1711 20th Avenue | 1715 20th Avenue

Design Review MUP Recommendation Packet | Project #3029632, #3029633 | February 13, 2019

1 Landscape Plan Scale: 1/8" = 1'-0" (24x36" Sheet Size)

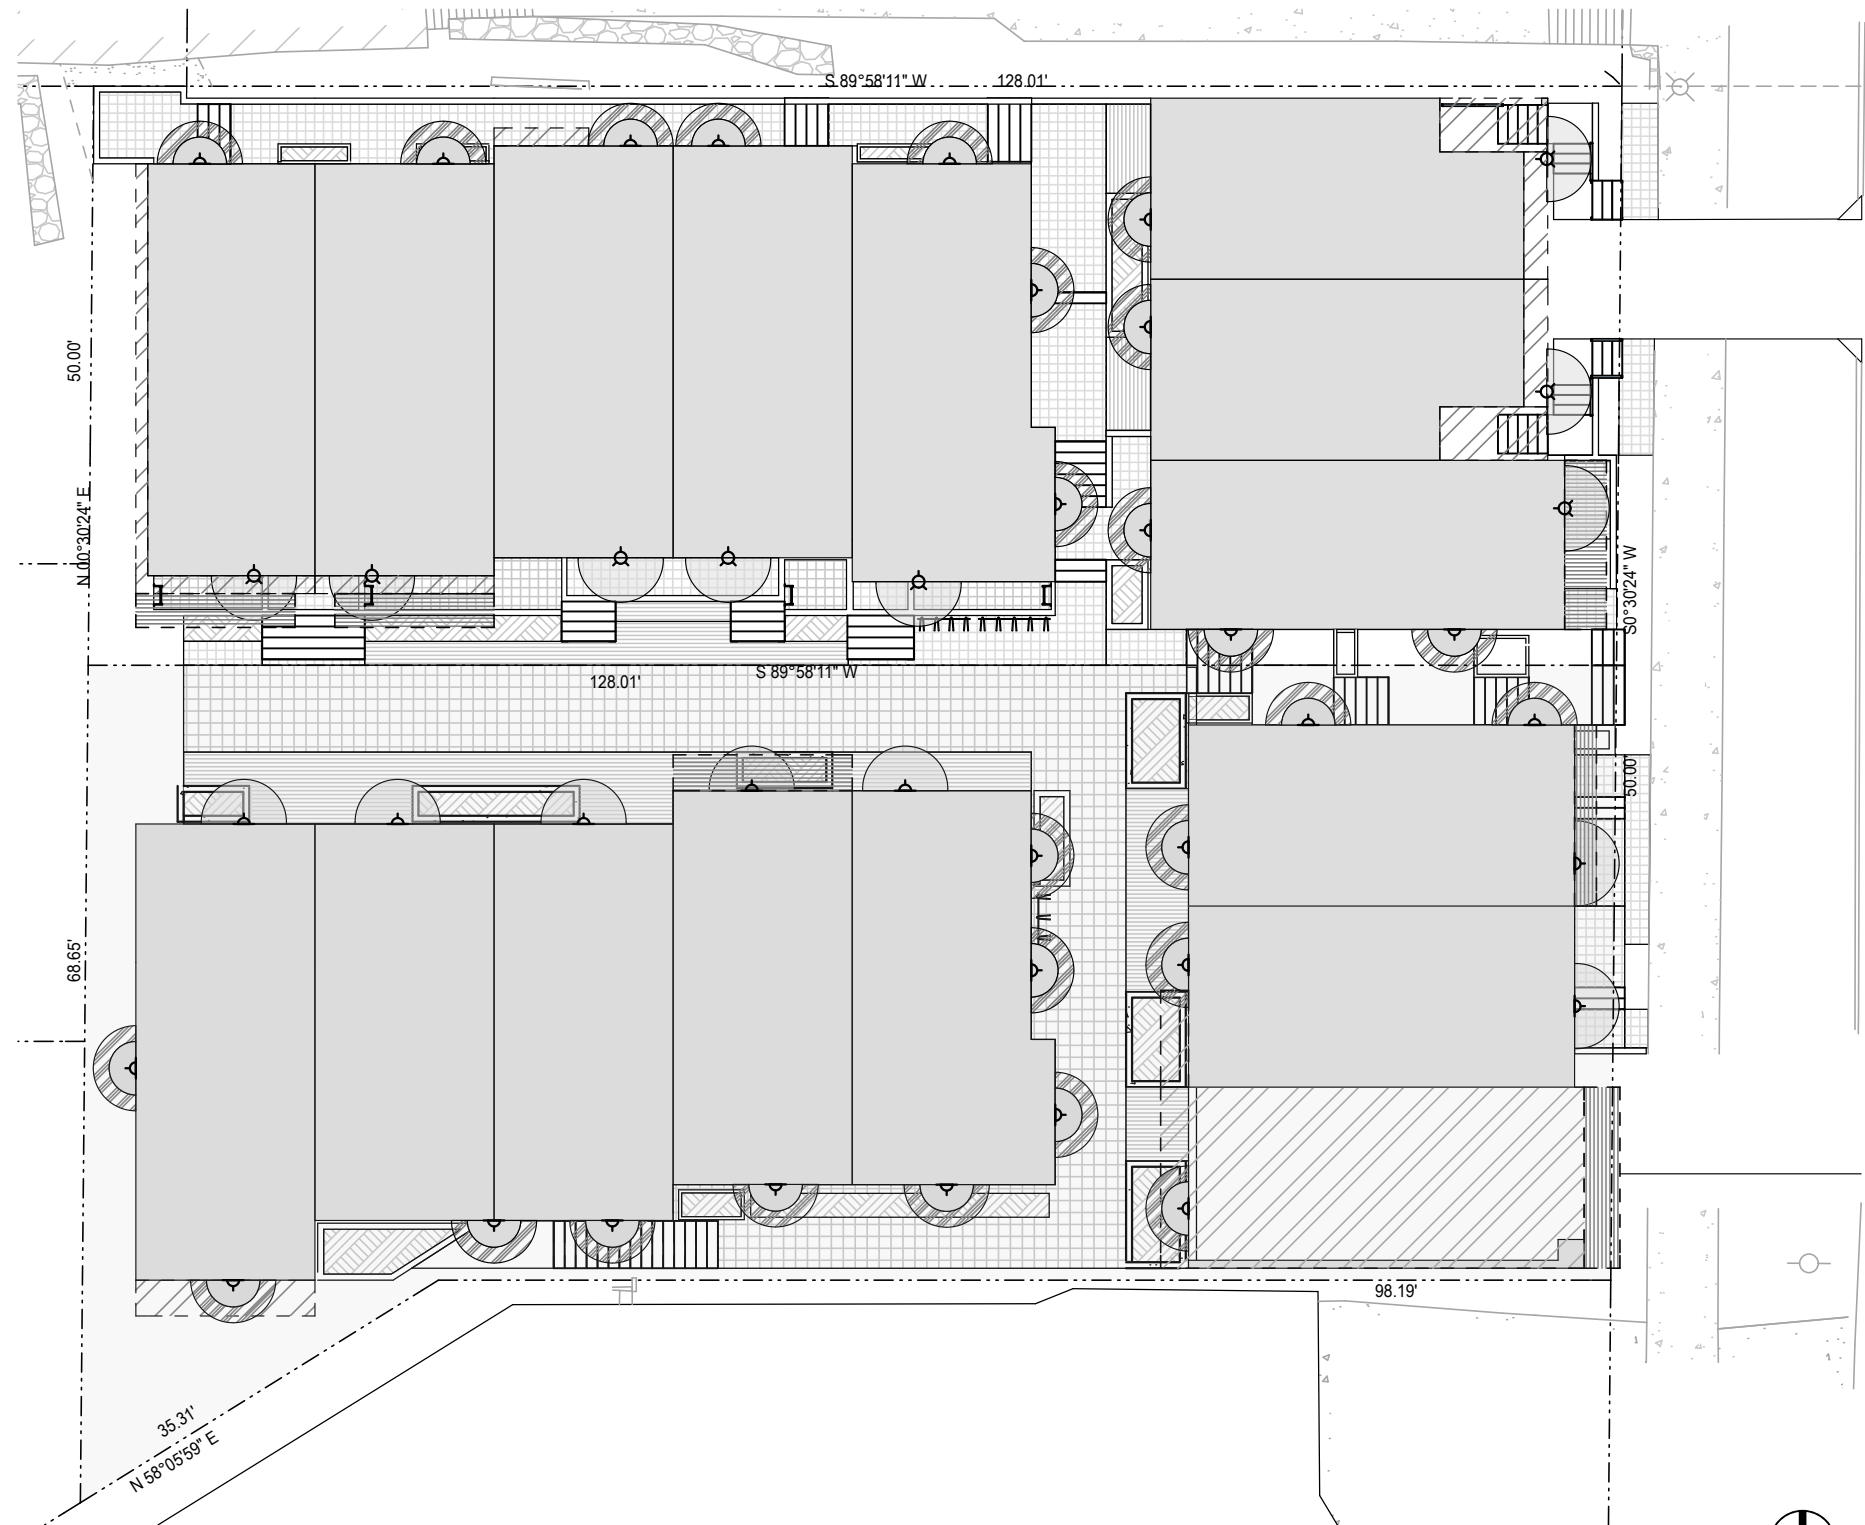
The Board was disappointed not to see a conceptual landscape plan, as two critical elements (the courtyard and the front-yard departure) were predicated on it.

- The landscape plan integrates a variety of ground surface textures to highlight individual spaces. Its design complements the architecture and engages the public realm along the 20th Avenue streetscape.
- The landscape plan proposes an integration of plantings and hardscape among a composition of planters, benches, and stoops to create usable and inviting exterior spaces.
